Access Compliance Report Public Rights-of-Way (Curb Ramps)

Main Street: RED_HILL_AVE		Cross Street: BULLARD_LN		Location:	NW
ADA ID: RPRK211014175306	Ramp Type:Type 1 - Perpendicular Diagonal Initial Pass/Fail: Fail		Overall Compliance: No	Severity Score:	16
Codes/Mitigation Info/Possible Solution			Field Measurements/Component Compliance

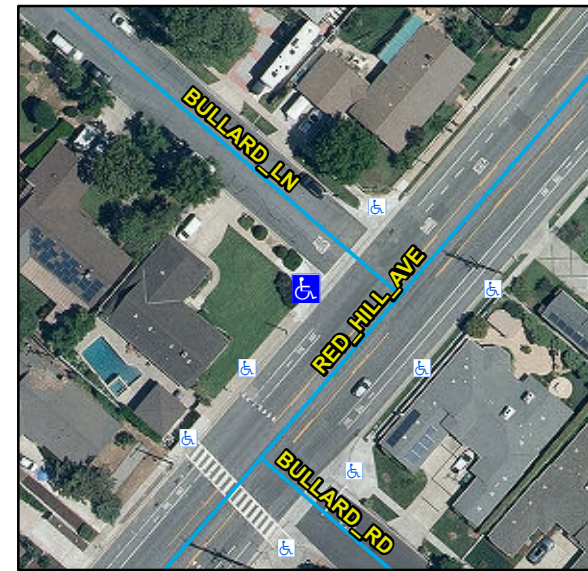
Remove & Replace Curb Ramp With Two New Directional Ramps or Equivalent.

R304.2.2, R304.5.3, STD 1115
